SAVANNAH PLACE ADDITION

RE: SUB 2000-82 -- One-Step Final Plat of SAVANNAH PLACE ADDITION

CASE NUMBER: SUB 2000-82 -- SAVANNAH PLACE ADDITION

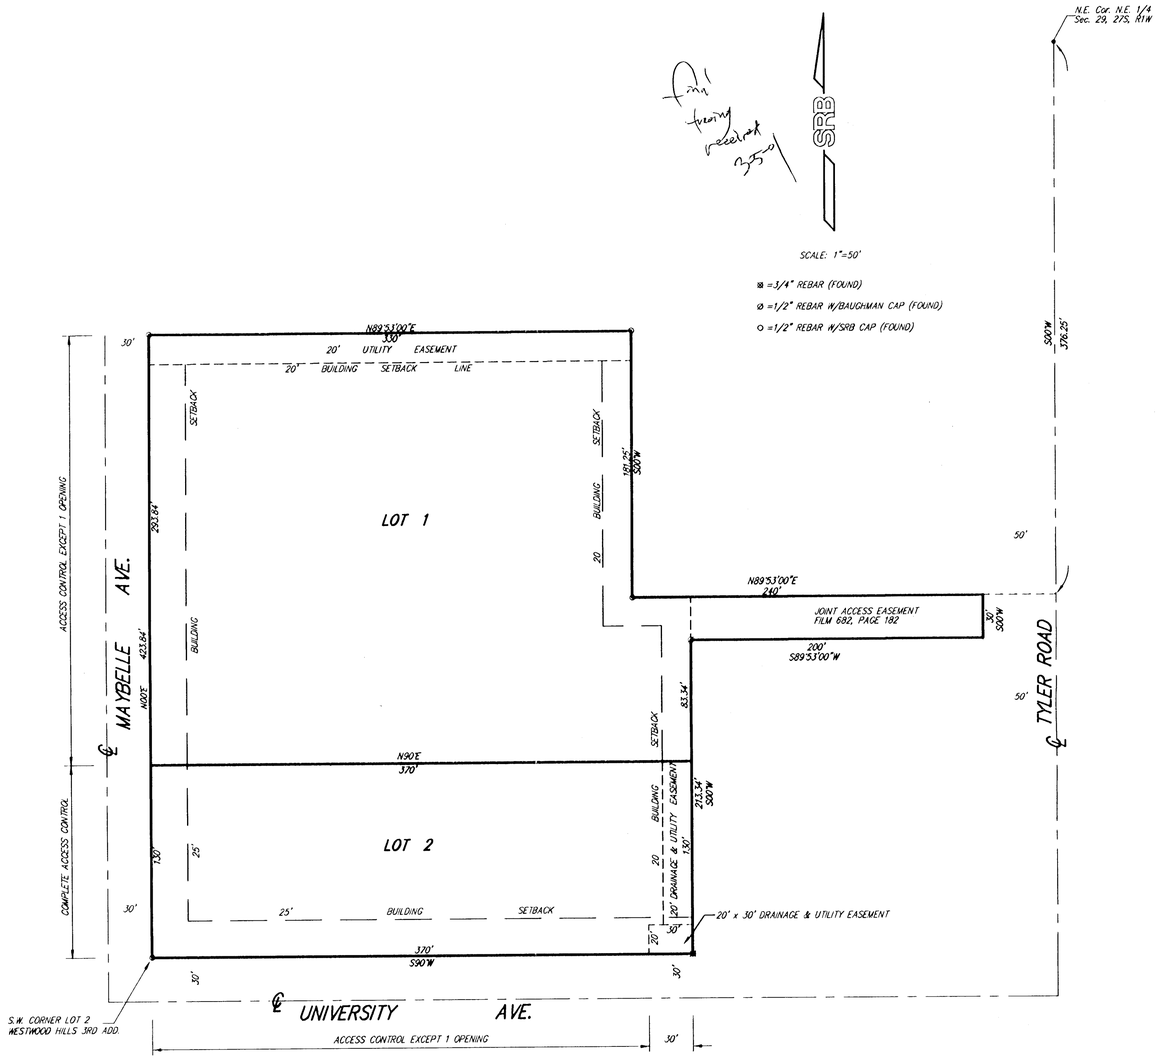
A. City Engineering has previously obtained petitions for City water and sanitary sewer with the Westwood Hills 3rd Addition. City Engineering needs to comment on the need for any additional guarantees or easements. *City Engineering has requested revised petitions.*

C. City Engineering needs to comment on the status of the applicant's drainage plan. *City Engineering has approved the drainage plan.*

D. A CUP administrative adjustment will need to be obtained regarding the revised setbacks and access controls.

F. As required by the sidewalk ordinance, sidewalks shall be provided along University Avenue and Maybelle Avenue. A sidewalk certificate was previously obtained with the Westwood Hills 3rd Addition.

G. The plattor's text shall include language that a drainage plan has been developed for the plat and that all drainage easements, rights-of-way, or reserves shall remain at established grades or as modified with the approval of the applicable City or County Engineer, and unobstructed to allow for the conveyance of stormwater.

Q. ***The applicant will be adjusting the interior lot line to the south 50 feet. The final plat tracing shall reflect this revision.***
